CERTIFICATE OF APPROPRIATENESS

- Application Date:** January 23, 2022
- Applicant:** Gordon Stenger, owner / Jose Ramirez, agent
- Property:** 515 Columbia St, Lot 9, Block 287, Houston Heights Subdivision. The property includes a historic 820 square foot, one-story wood frame single-family residence and a detached garage situated on a 6,600 square foot (50' x 132') interior lot.

- Significance:** Contributing Gable-front Cottage residence, constructed circa 1910, located in the Houston Heights South historic district.
- Proposal:** Alteration and Addition:

Side Wall Length and Insets (Addition and New Construction)

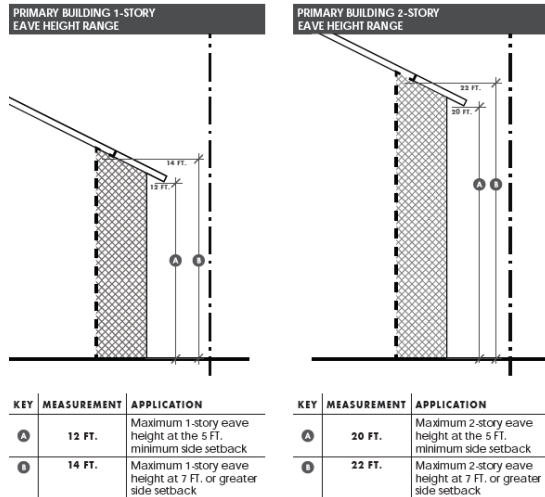
Inset depth: 2'-0"

Inset length: 6'-0"
